I, SCOTT J. STEFFEN, NMPE 14664, OF THE FIRM BOHANNAN HUSTON, HEREBY CERTIFY THAT THIS PROJECT IS IN SUBSTANTIAL COMPLIANCE WITH AND IN ACCORDANCE WITH THE DESIGN INTENT OF THE EPC APPROVED PLAN DATED 2/22/12. THE RECORD INFORMATION EDITED ONTO THE ORIGINAL DESIGN DOCUMENT HAS BEEN OBTAINED BY SURVTEK. I FURTHER CERTIFY THAT I HAVE PERSONALLY VISITED THE PROJECT SITE ON 1/31/13, 2/13/13, 4/18/13, 5/23/13, 6/17/13, 6/27/13, 8/1/13, 8/28/13, 11/5/13, 11/14/13, 12/23/13 AND 1/30/14 AND HAVE DETERMINED BY VISUAL INSPECTION THAT THE SURVEY DATA PROVIDED IS REPRESENTATIVE OF ACUTAL SITE CONDITIONS AND IS TRUE AND CORRECT TO THE BEST OF MY KNOWLEDGE AND BELIEF. THIS CERTIFICATION IS SUBMITTED IN SUPPORT OF A REQUEST FOR PERMANENT CERTIFICATE OF OCCUPANCY.

SITE DEVELOPMENT PLAN
FOR BUILDING PERMIT
DIAMOND MESA

ADMINISTRATIVE AMENDMENT
FILE # 13-10302 **PROJECT #** 1002819
SEE ⚠2
2/13/2014
APPROVED BY **DATE**

⚠2 Revised February, 2014

SITE DEVELOPMENT PLAN
FOR BUILDING PERMIT
DIAMOND MESA

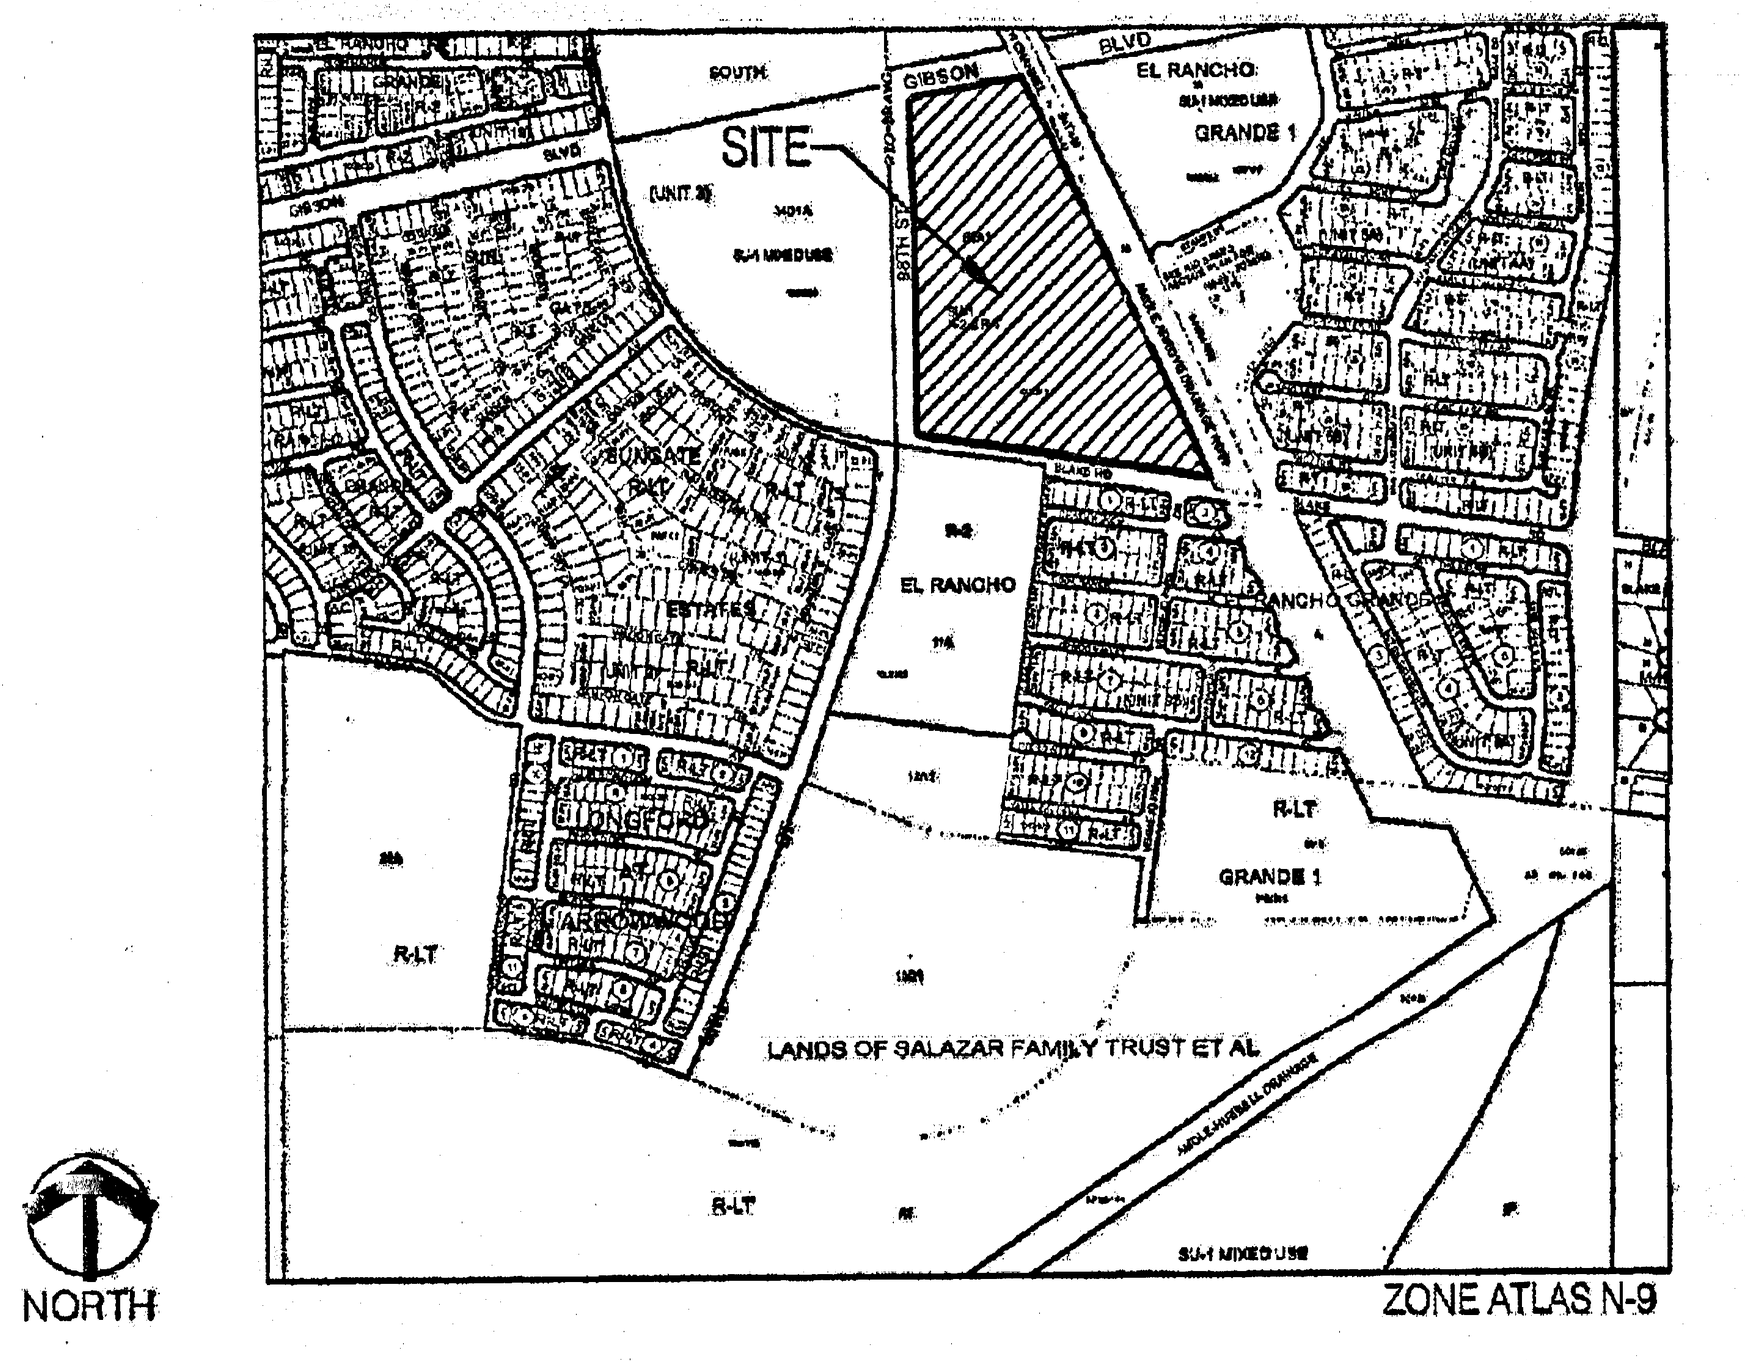
△1 The following changes are proposed:
1. Modify the building footprints to accommodate slightly smaller units;
2. Modify the building elevations;
3. Update the notes, open space, and landscape calculations;
4. Amend the pedestrian connections to better connect to the internal pedestrian circulation network and grade changes;
5. Eliminate one detached unit and replace with a community "club room"; and
6. Reduce turf areas and modify the landscape plan accordingly.

△2 Revised February, 2014
1. Eliminate and add pedestrian crossings as needed.
2. Remove details for private Pocket Parks to allow flexibility.
3. Eliminate sidewalk located west of Building #33.
4. Revise entrance lane off of Blake Road to 20 feet.
5. Revise bike rack location.
6. Add existing covered Mail Box Center.
7. Add a pedestrian connection just south of Building #39.

Sheet 1 of 15

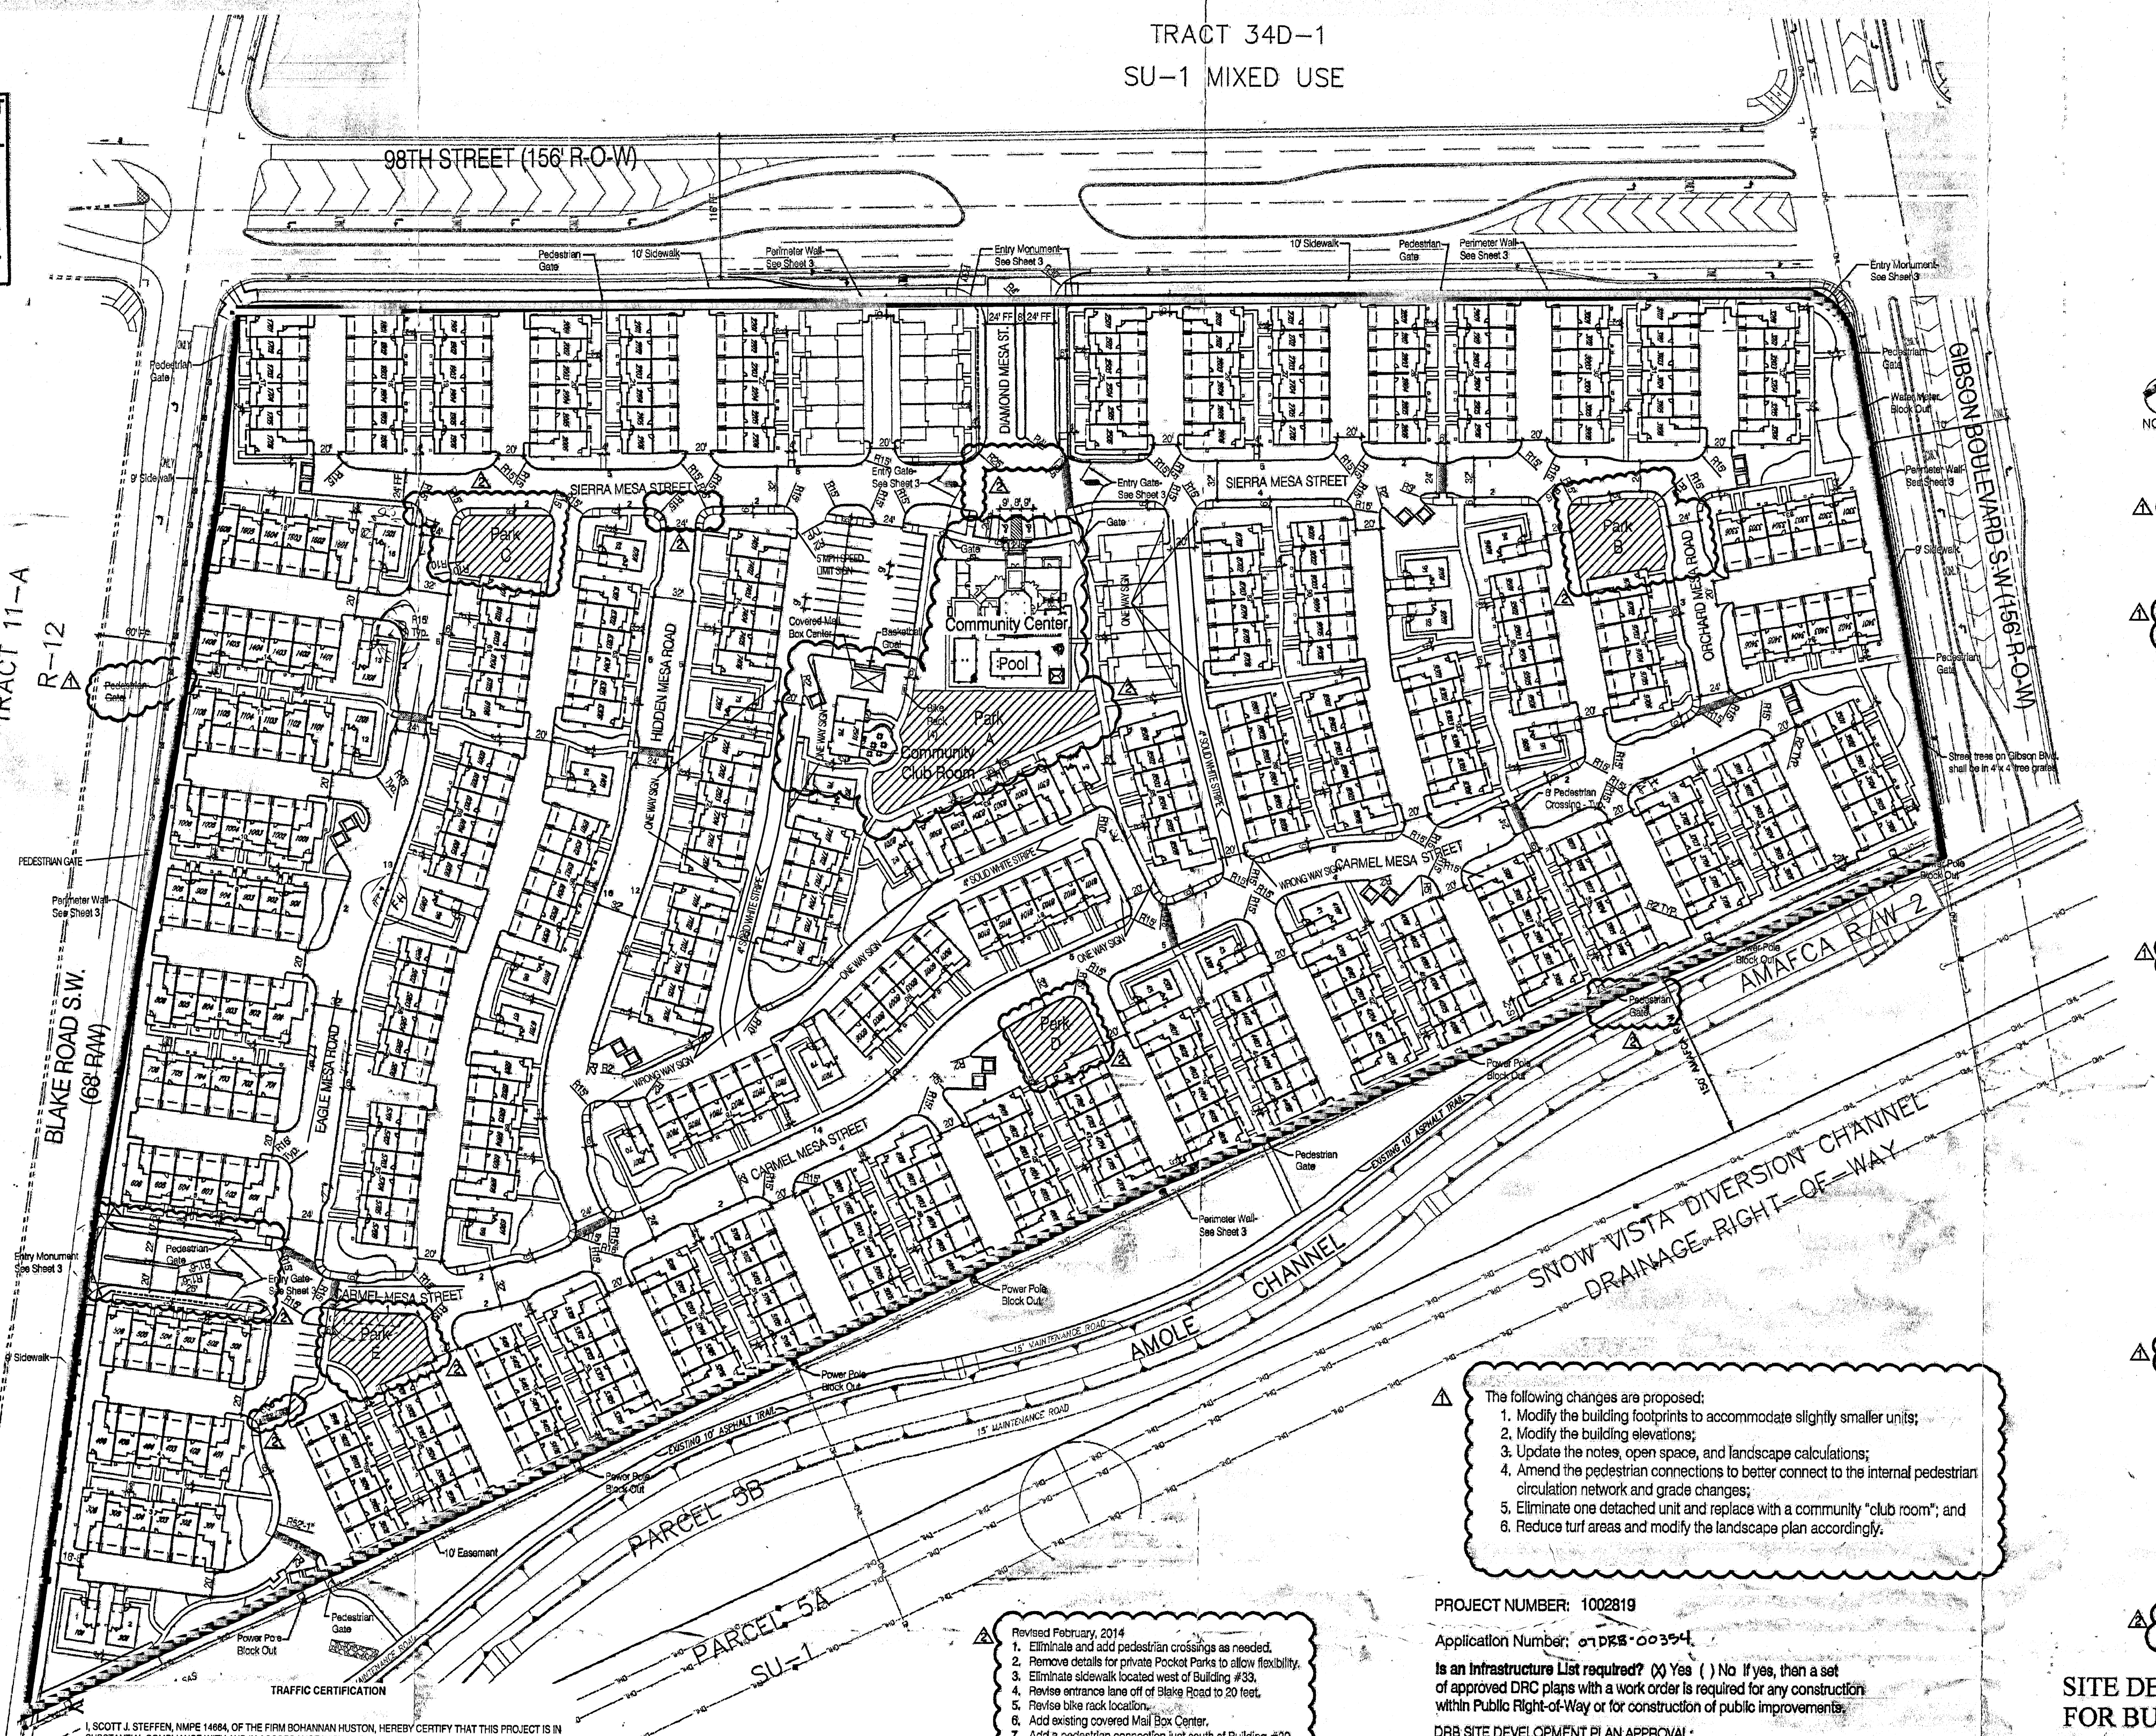
⚠1 The following changes are proposed:

1. Modify the building footprints to accommodate slightly smaller units;
2. Modify the building elevations;
3. Update the notes, open space, and landscape calculations;
4. Amend the pedestrian connections to better connect to the internal pedestrian circulation network and grade changes;
5. Eliminate one detached unit and replace with a community "club room"; and
6. Reduce turf areas and modify the landscape plan accordingly.

1. Eliminate and add pedestrian crossings as needed.
2. Remove details for private Pocket Parks to allow flexibility.
3. Eliminate sidewalk located west of Building #33.
4. Revise entrance lane off of Blake Road to 20 feet.
5. Revise bike rack location.
6. Add existing covered Mail Box Center.
7. Add a pedestrian connection just south of Building #39.

Sheet 1 of 15

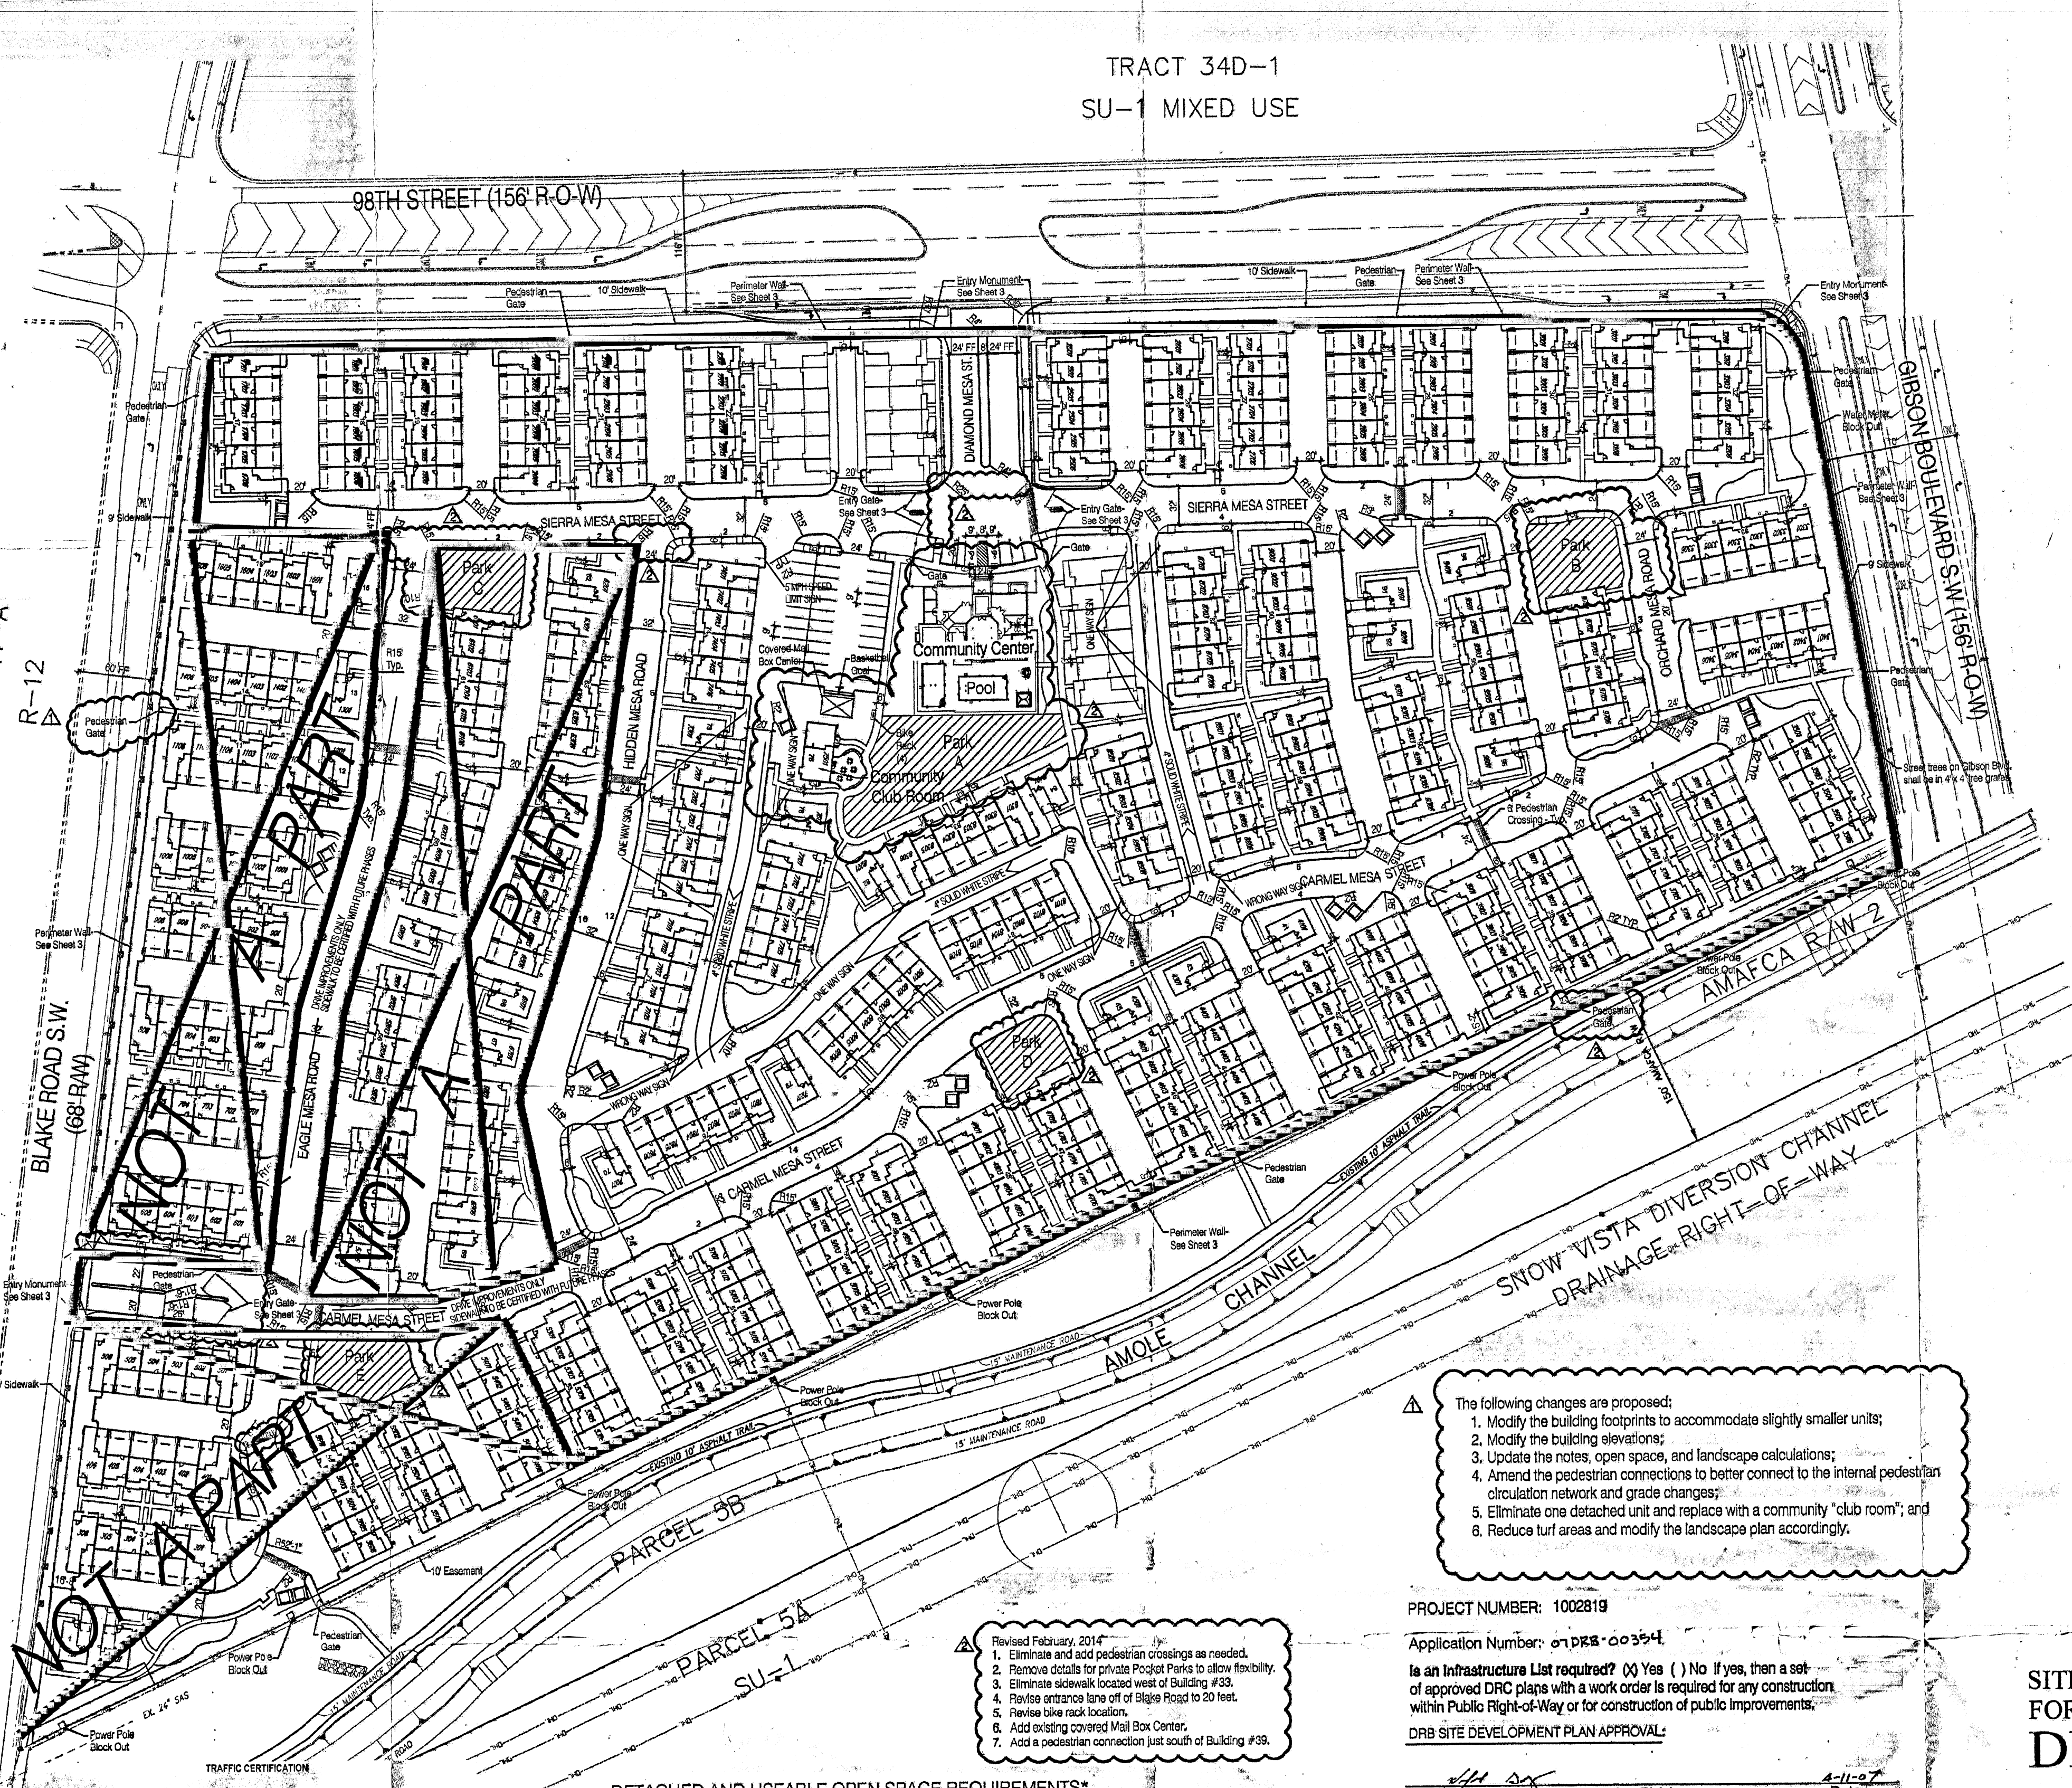
△1 The following changes are proposed:
1. Modify the building footprints to accommodate slightly smaller units;
2. Modify the building elevations;
3. Update the notes, open space, and landscape calculations;
4. Amend the pedestrian connections to better connect to the internal pedestrian circulation network and grade changes;
5. Eliminate one detached unit and replace with a community "club room"; and
6. Reduce turf areas and modify the landscape plan accordingly.

△2 Revised February, 2014
1. Eliminate and add pedestrian crossings as needed.
2. Remove details for private Pocket Parks to allow flexibility.
3. Eliminate sidewalk located west of Building #33.
4. Revise entrance lane off of Blake Road to 20 feet.
5. Revise bike rack location.
6. Add existing covered Mail Box Center.
7. Add a pedestrian connection just south of Building #39.
